RE: Briar Chapel: Request to Add a Riparian Buffer and for Waiver/Reduction of Certain Riparian Buffers

This letter serves as a formal request by NNP-Briar Chapel, LLC to adjust the riparian buffer map for Briar Chapel as follows:

ORDER OF THE BOARD OF COMMISSIONERS OF CHATHAM COUNTY AUTHORIZING ADDITION OF A RIPARIAN BUFFER AND ADJUSTMENTD TO TWO RIPARIAN BUFFERS AT BRIAR CHAPEL

New Stream A Exhibit

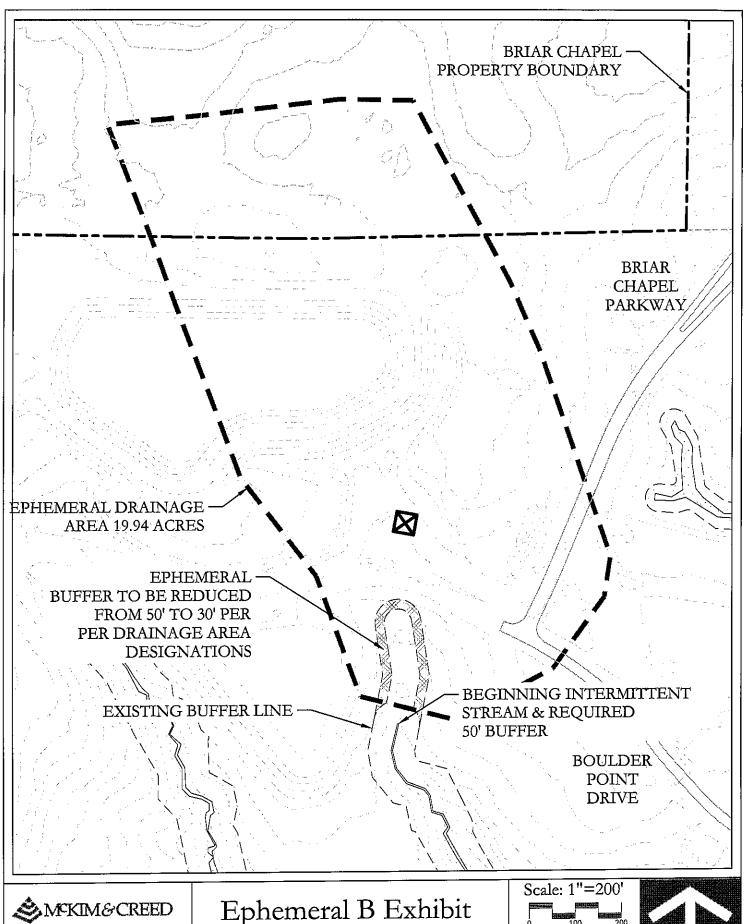
1. Request to add a new 50' buffer along an intermittent stream as shown on Exhibit A.

In the process of developing the Briar Chapel West area and also while in the process of mapping the adjoining US Steel property, consultants for Briar Chapel encountered an intermittent stream not previously shown on the site plan for Briar Chapel. Based on the requirements of the CCO, this intermittent stream would require a 50' buffer. Briar Chapel takes its commitment to the environment seriously and believes it is important to reveal the existence of this stream and buffer it accordingly. As such, Briar Chapel seeks an adjustment to its current requirements to add the proposed 50' buffer in the area shown on Exhibit A. The location of this buffer may cause a slight adjustment of the location of lots as shown on the 2012 amended site

plan for this area but the change is not deemed significant enough to require an adjustment of the site plan itself.

- 1. The recitals set forth above are incorporated in this Order.
- 2. The request to add a 50' buffer as shown on New Stream A Exhibit attached hereto, is hereby granted;
- 3. The request to reduce a riparian buffer from 50' to 30' based on drainage area as shown on Ephemeral B Exhibit attached hereto, is hereby granted;
